June 27, 2014
NRC:14:041

U.S. EPR Design Certification Application - Closure of FSAR Chapter 10

ENCLOSURE 1
FINAL MARK-UPS FOR CHAPTER 10 AND CONFORMING CHANGES FOR FSAR
REVISION

Figure 10.3-1—Main Steam Supply System
Sheet 1 of 2

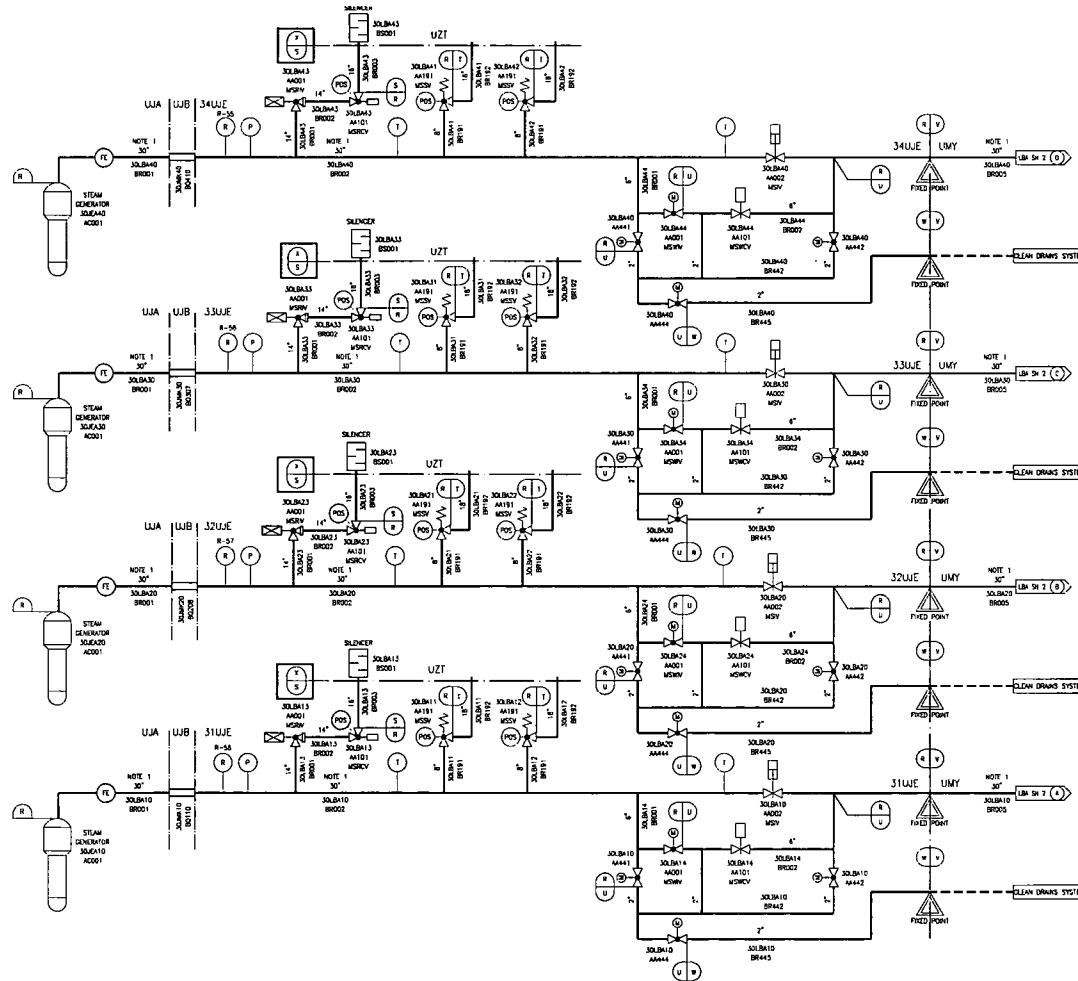
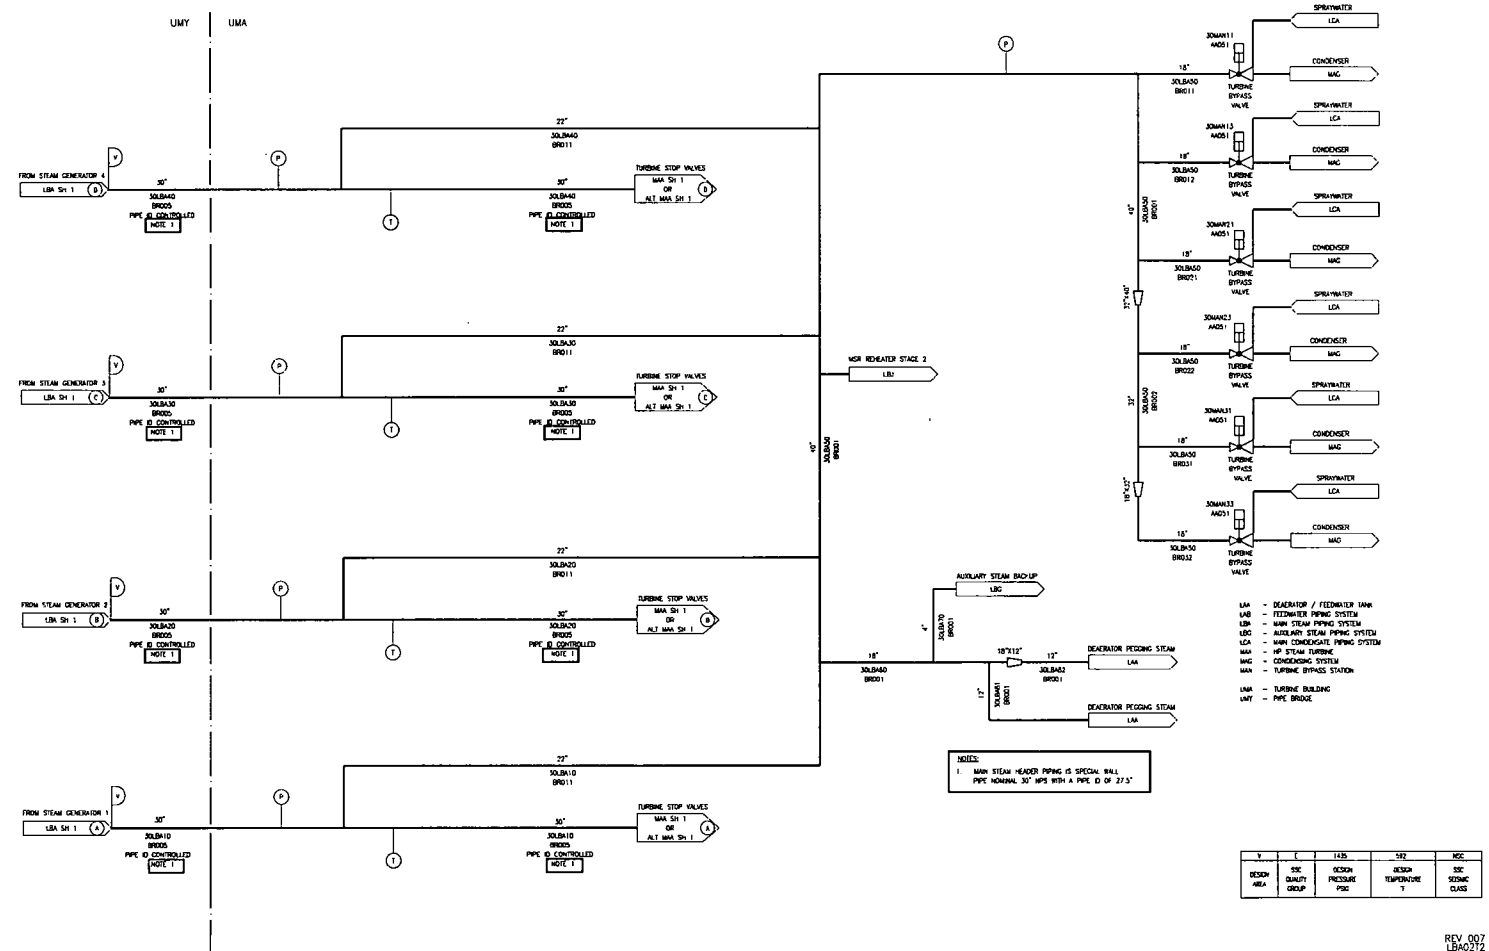
Description of Change	Pages Affected
Editorial/typographical changes identified as part of the Chapter 10 freeze process.	Page 10.3-2 Page 10.3-26 Page 10.4-53 Table 10.3-4 Table 10.4.7-2
Conforming changes consistent with discussion during Chapter 11 Public Meeting held on March 5, 2014, related to design information for radiation monitors.	Page 10.4-3 Page 10.4-6 Page 10.4-9 Page 10.4-15 Page 10.4-29
<p>Conforming changes to safety classification, quality group, seismic category and/or EQ designation based on updated source documentation (e.g., system description, design requirements).</p> <p>Source documents have been revised through the implementation of the following DCRs:</p> <ul style="list-style-type: none"> • DCR 113-7015514-000, "Edits to Main Steam System Source Documents for FSAR Chapter 10 Closeout." • DCR 113-7015515-000, "Change of Water Supply to Condenser Evacuation System Separator / Silencer and Edits to Condenser Evacuation Source Documents for FSAR Chapter 10 Closeout." • DCR 113-7015517-000, "Edits to Circulating Water System Source Documents for FSAR Chapter 10 Closeout." • DCR 113-7015518-000, "Changes to Rated Condensate Flow and Edits to Condensate Polishing System Source Documents for FSAR Chapter 10 Closeout." • DCR 113-7015519-000, "Design Area Changes for Feedwater Pumps." • DCR 113-7015520-000, "Edits to Central Gas Supply System Source Documents for Steam Generator Blowdown System FSAR Chapter 10 Closeout." • DCR 113-7015521-000, "Changes to Main Steam and Reheat Steam Systems for FSAR Chapter 10 Closeout." 	<p>Page 10.2-12 Page 10.3-11 Page 10.3-25 Pages 10.3-36, 10.3-37 Pages 10.4-19, 10.4-35, 10.4-39, 10.4-44, 10.4-82 Page 10.4-11 Page 10.4-12 Page 10.4-16 Page 10.4-26 Page 10.4-50 Page 10.4-54 Page 10.4-69 Page 10.4-100 Page 10.4-101 Page 10.4-102 <u>Tier 1:</u> Page 2.8-26</p> <p>Table 10.3-4 Figure 10.3-1 Figure 10.4.2-1 Figure 10.4.2-2 Figure 10.4.3-1 Figure 10.4.5-1 (Sheet 1) Table 10.4.7-1 Figure 10.4.7-1 (Sheet 1) Figure 10.4.8-1 (Sheet 2) Table 10.4.9-4 Table 10.4.9-5 Figure 10.4.9-1 (Sheet 1) Figure 2.8.2-1 (Sheet 1)</p>
